**Subject: Beaver Valley Power Station, Unit No. 1 and No. 2
BV-1 Docket No. 50-334, License No. DPR-66
BV-2 Docket No. 50-412, License No. NPF-73
Supplemental Information in Support of 2001-2002 Steam Generator
Tube Outages Inspection Reports**

This letter provides the FirstEnergy Nuclear Operating Company (FENOC) response to the NRC request for additional information (RAI) dated June 4, 2003, pertaining to various previously submitted reports summarizing the steam generator tube inspections performed during refueling outages 1R14 and 2R09 on Beaver Valley Power Station (BVPS) Units 1 and 2, respectively.

Letter L-03-110 - ATTACHMENT A

Information in Response to a Request for Additional Information
for Beaver Valley Power Station, Unit No. 2

FIGURE 1

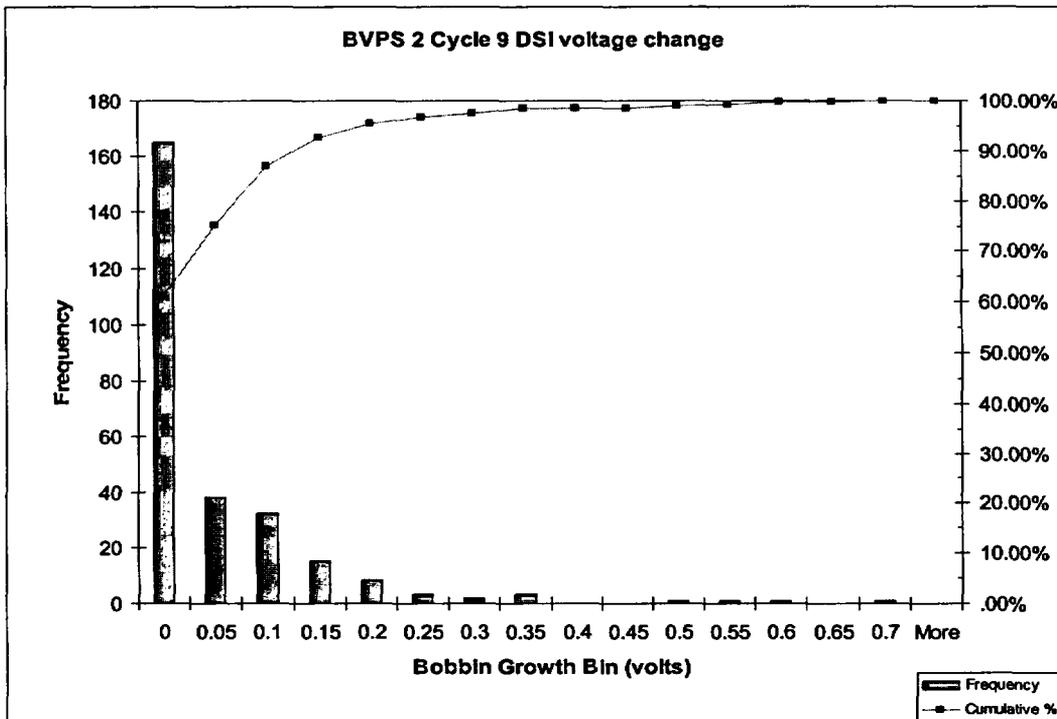
Please trend the number of distorted support plate indications (DSIs) at tube support plate intersections over time. Provide a summary of the growth rate for those indications with time. For the DSIs that were confirmed as flaws with the +Point probe, discuss the history of these indications. Compare the percentage of DSI indications showing measurable growth to the percentage of DSI indications that had a flaw identified by +Point examination. Discuss what actions, if any, have been taken to investigate the reason for the high percentage of DSIs that do not confirm as flaws during the +Point examination.

Additionally, the overall DSI amplitude growth for BVPS 2 Cycle 9 is negligible. The largest singular bobbin amplitude growth in any SG was 0.70 volts, with an average growth of -0.03 volts. Figure 1 provides a cumulative probability distribution function of DSI growth for Cycle 9. An overwhelming majority of the growth values are within the typical repeatability bounds for the bobbin coil.
